**AGENDA FOR REGULAR MEETING
VILLAGE OF TINLEY PARK
PLAN COMMISSION
February 19, 2015 – 7:30 P.M.
Council Chambers
Village Hall - 16250 South Oak Park Avenue**

**ITEM #1 MAHER FUNERAL HOME (JOHN MAHER, PETITIONER) – 17101 71st AVENUE
– SPECIAL USE PERMIT FOR AN ACCESSORY APARTMENT, FRONT YARD
SETBACK VARIATION, AND SITE PLAN APPROVAL FOR A FUNERAL HOME
(New Item)**

PLAN COMMISSION

The Applicant proposes to convert the former Tinley Park Library, located at 17101 71st Avenue, into a new funeral home facility with a one-bedroom apartment as an accessory use. The proposed apartment use requires a Special Use Permit. As part of the Special Use process, the Plan Commission must review the proposed site plan and elevation changes.

**SITE PHOTOMETRIC PLAN**
SCALE: 3/32" = 1'-0"

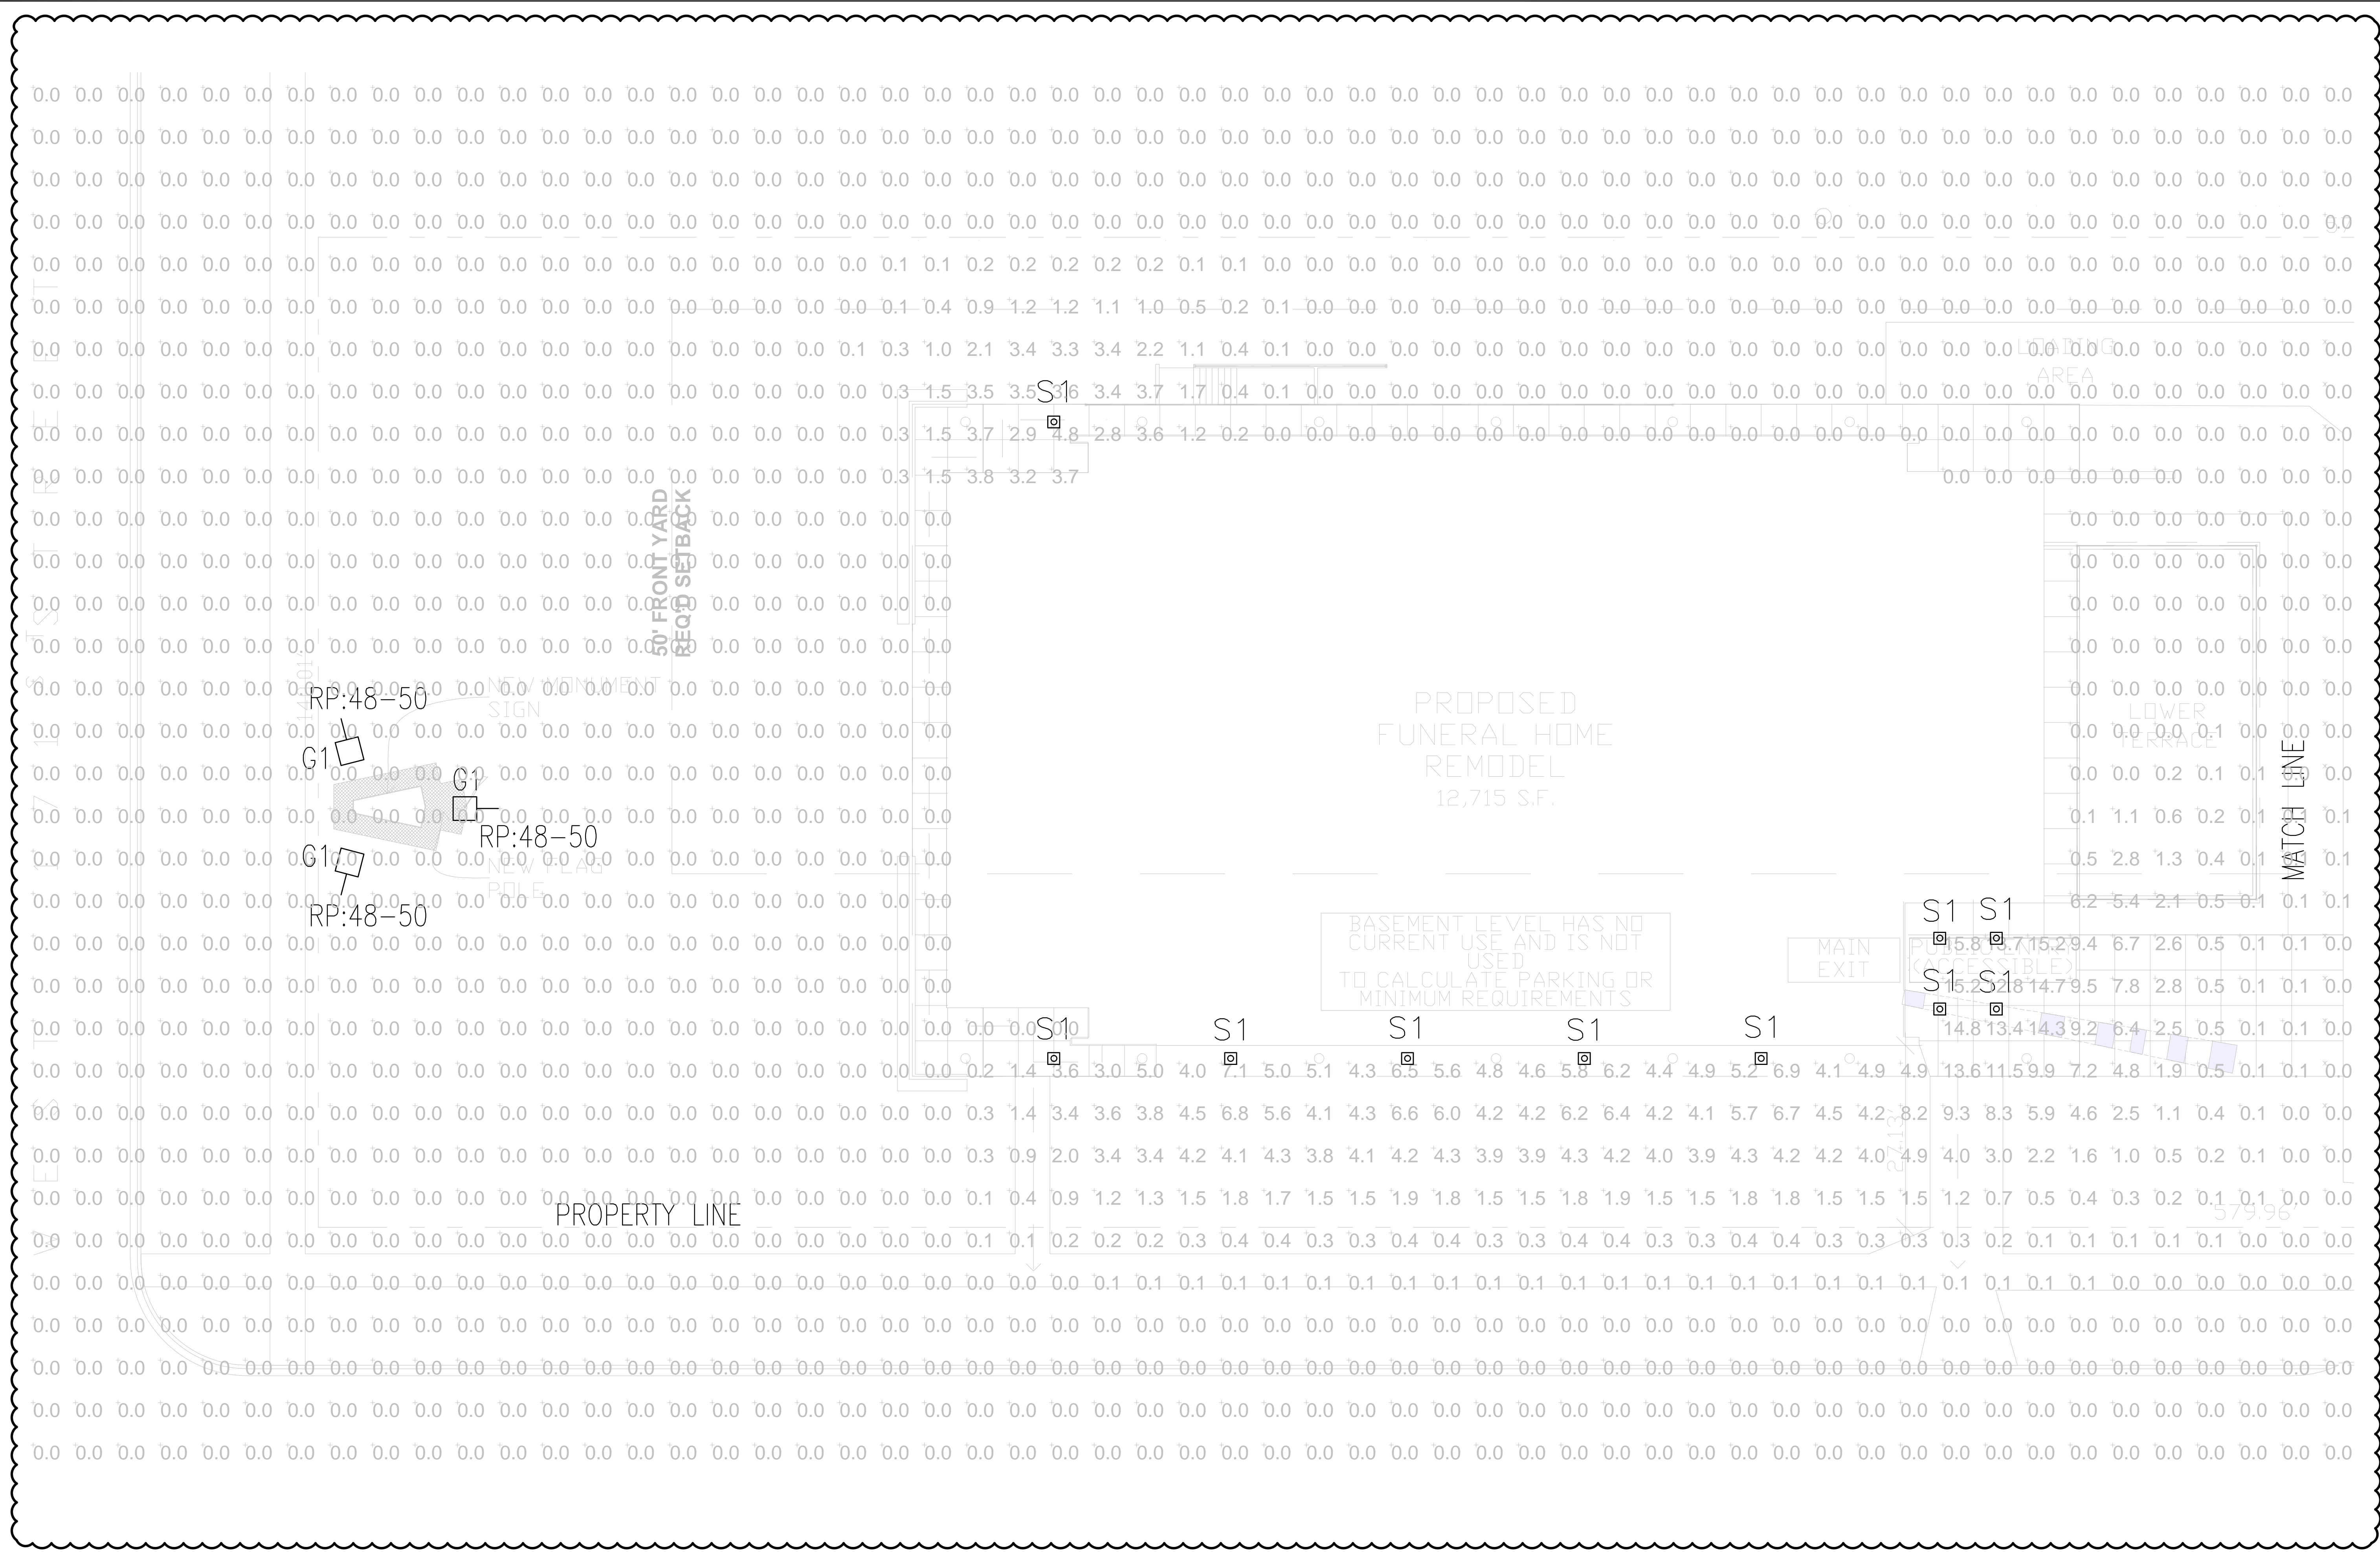
The architect has proposed to use three (3) of the five (5) existing light standards in the parking lot. The two (2) lights mounted on the Com Ed poles on the east property line will not be used and will be removed. This will aid in mitigating any light spillage onto the adjacent residential properties. A photometric plan has been reviewed and found to be in compliance with Village code. The remaining existing light poles will be retrofitted with new LED lighting.
